Contractor:  TIANCHEN CORP. CHINA	Project :	MKP Methanol Project			Owner :  شرکت کیمیای پارس خاورمیانه Middle East Kumiya Pars Co.
	Unit	General Technical	Phase	Detail Engineering	
	Doc. Title :	PACKAGE HAZOP			
Vendor :  新鼎信息技術(上海)有限公司 Advanced Control & Information Technologies Co., Ltd.	Owner No.	MKP-11-DE-9000-SF-RPT-001B			Rev. : 0
	Contr. No.:	MKP-11-DE-9000-SA01-RPT-001B			
	Vendor No.	16E2416A			Page : 1 of 25

PACKAGE HAZOP

Node 7009

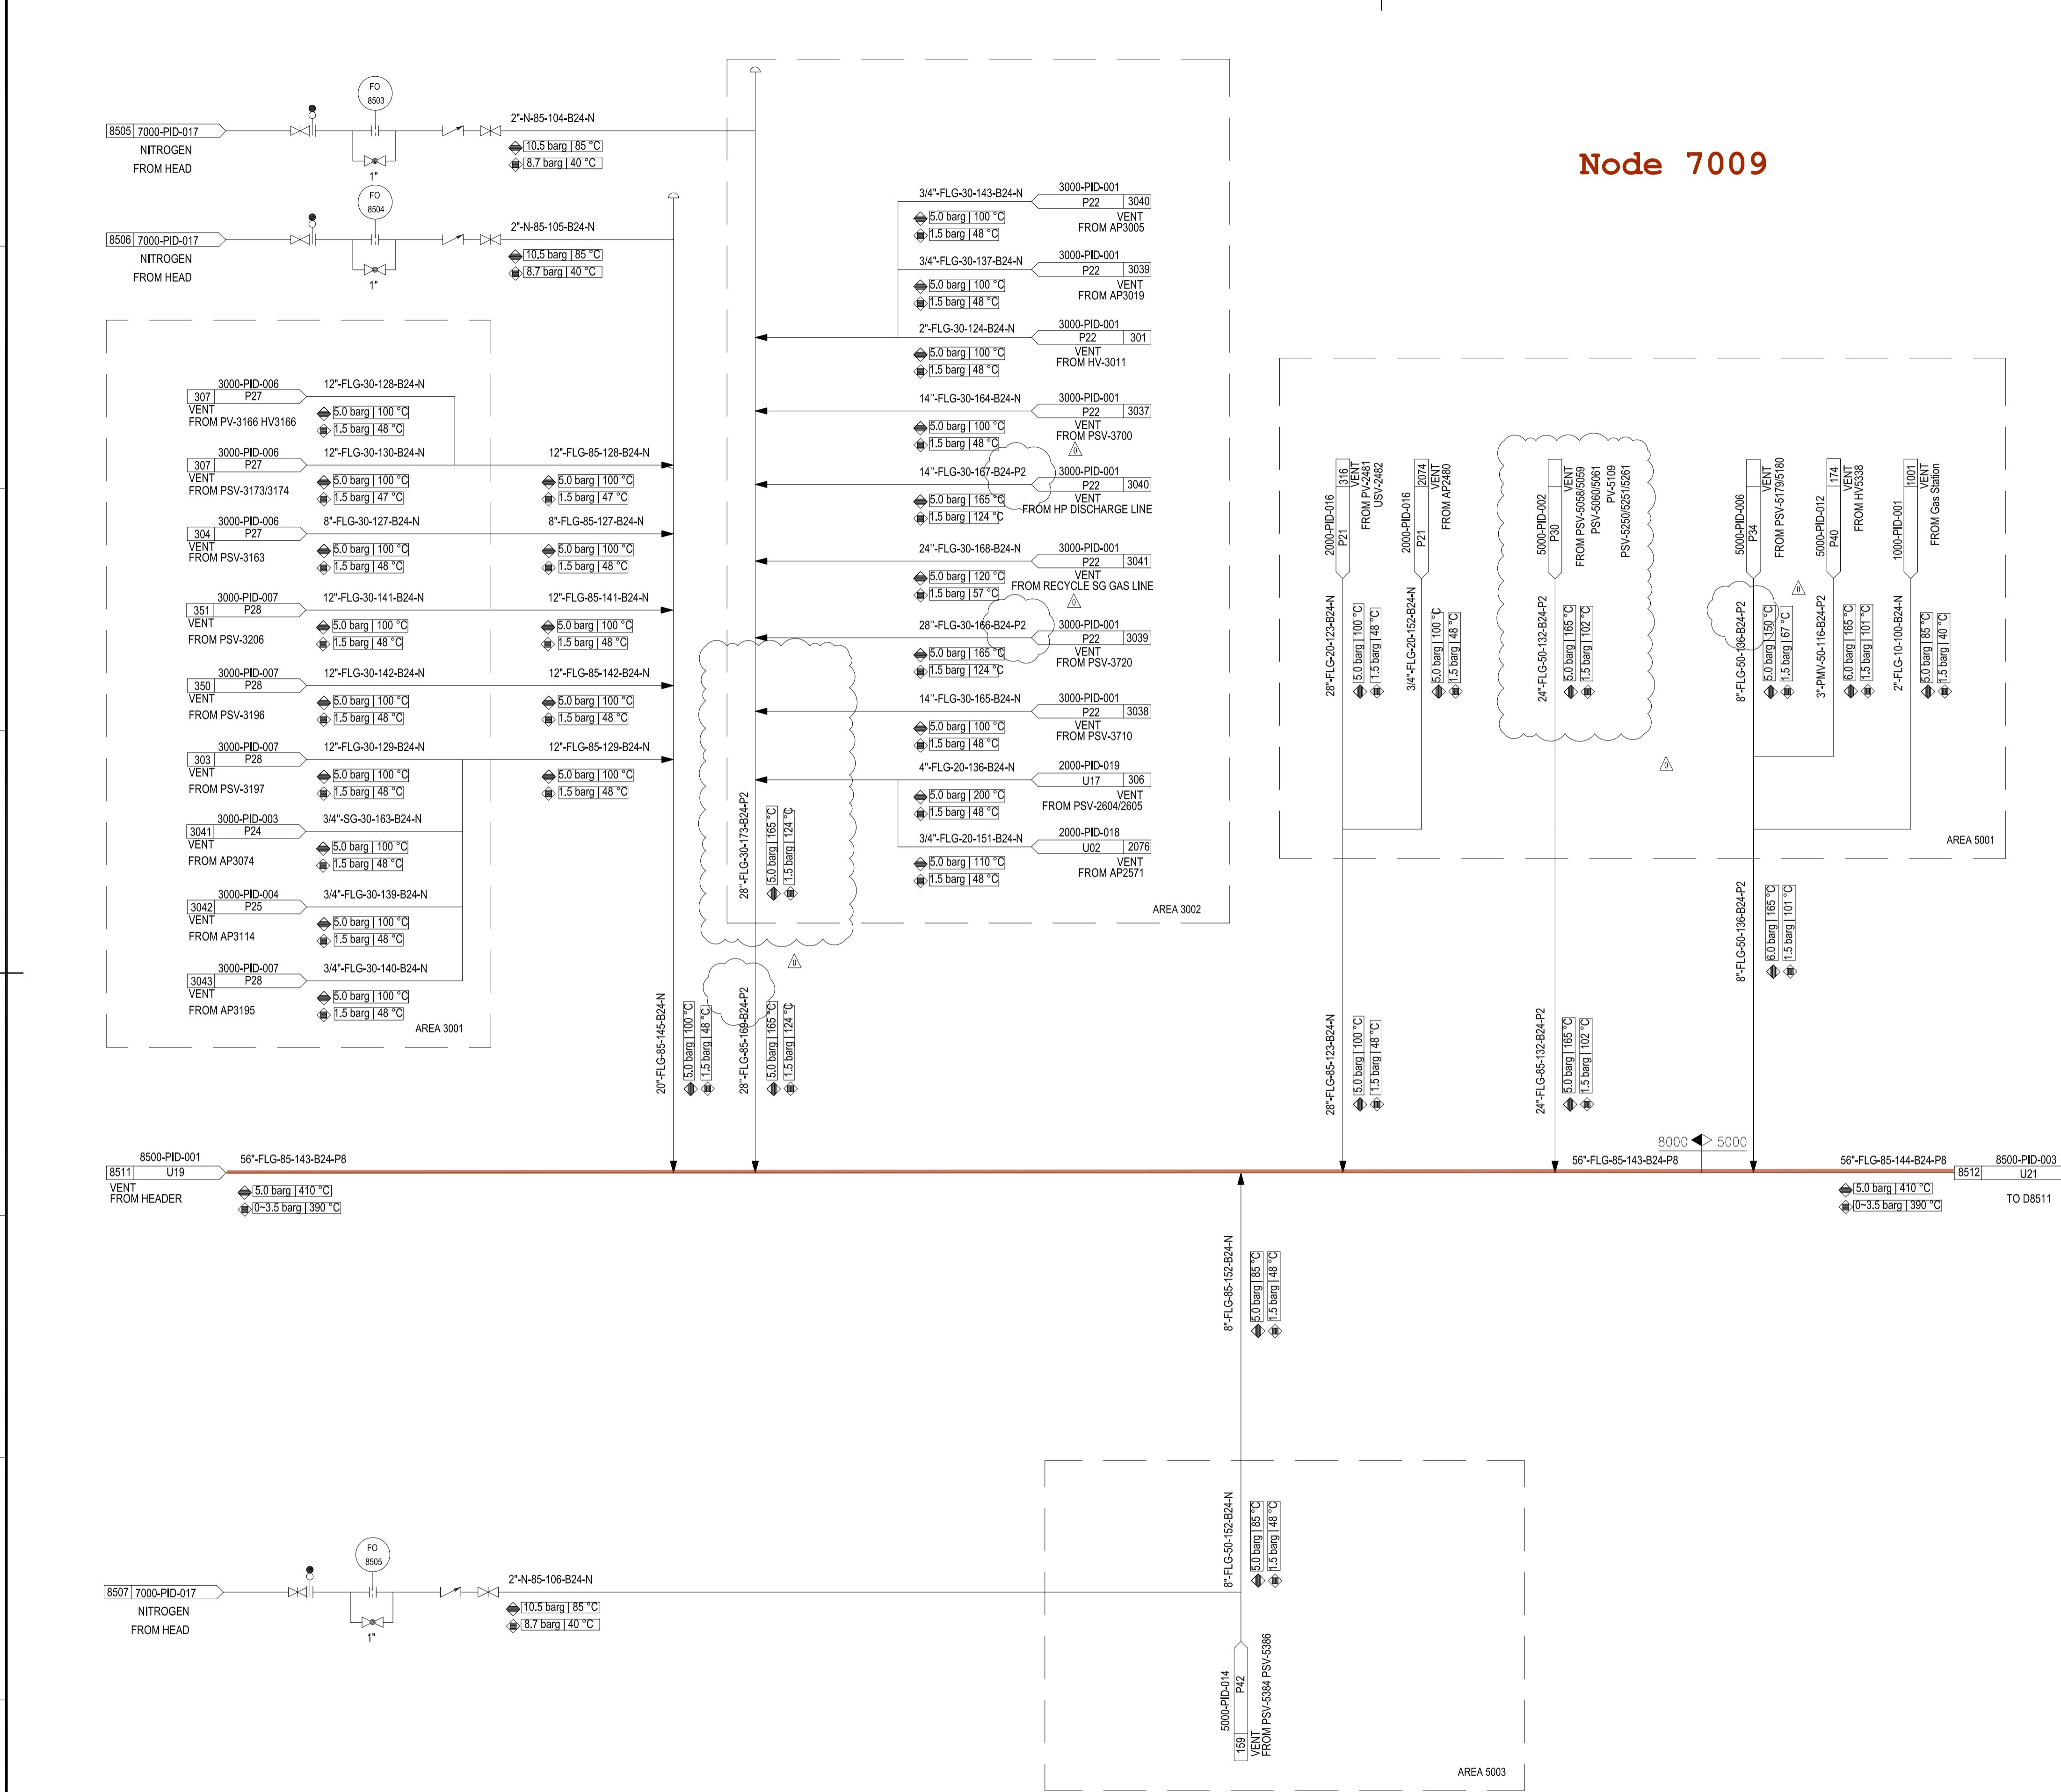
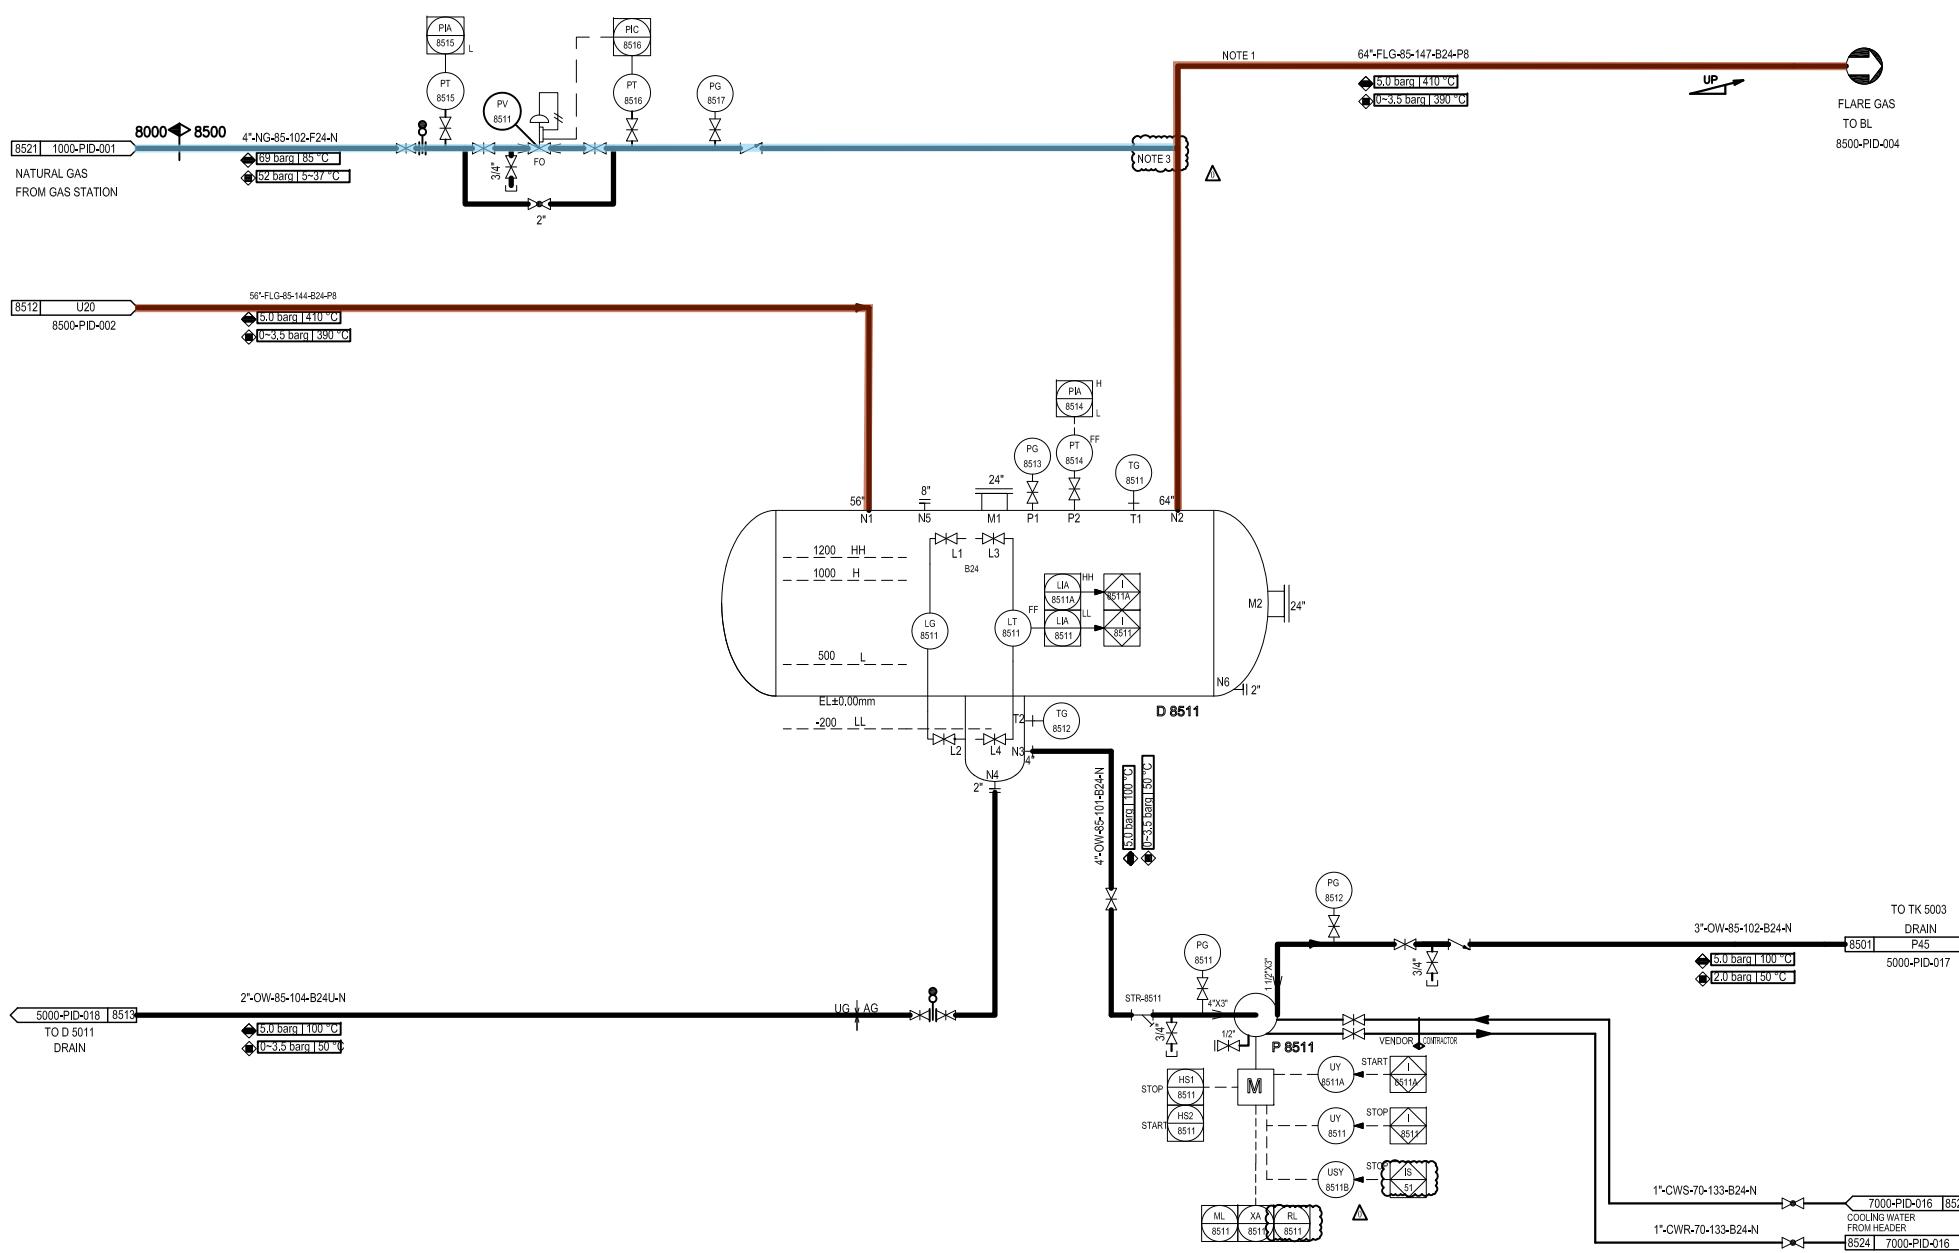
7009.11	3	Vendor to advise: TIAS/TV-8544 as a safeguard.	Y			TCC
7009.13		HAZOP study should be done by vendor for flare gas system package, the owner will check flare package after receiving vendor data.	Y			TCC
7010.9	2	1.Add plant air connection for portable pumps.	Y			TCC
7010.13		1.Consider curb with anti-acid brick for H ₂ SO ₄ solution tank and NaOH solution tank.	Y			TCC
7201.3	2	1.Add a temperature transmitter and send the signal to control room, set high alarm in the 8"-TC-72-201-B50-N inlet line of X-7201A/B and X-7204.	Y			TCC
7201.5	3	1.Change FIQ-7204 to FI-7204.	Y			TCC
7201.6	2	1.Add low alarm for FT-7205.	Y			TCC
7201.7	2	1.Add low alarm for FI-7201. 2. Add FI and low alarm for FI-7204 (DMW from B.L)	Y			TCC
7201.8	2	1.Add low alarm for FT-7203A/B.	Y			TCC

. 7	high pressure(D-8502)	1 PT/PIC/PV-8529 fail open.	D-8502 overpressure.	D-8502 have a PSV.	4	4	4	Y	PG-8541 change to PT-8541 and send a signal to PLC and add high pressure alarm.
. 8	low pressure(D-8502)	1 1.PSV of D-8502 open prematurely or leak. 2.PT/PIC/PV-8529 fail closed.	Pilot gas supply failure.	PIA-8527 low pressure alarm.	3	4	3	N	PG-8541 change to PT-8541 and send a signal to PLC and add low pressure alarm.
. 9	low pressure(flare gas)	1 No significant issue identified.						N
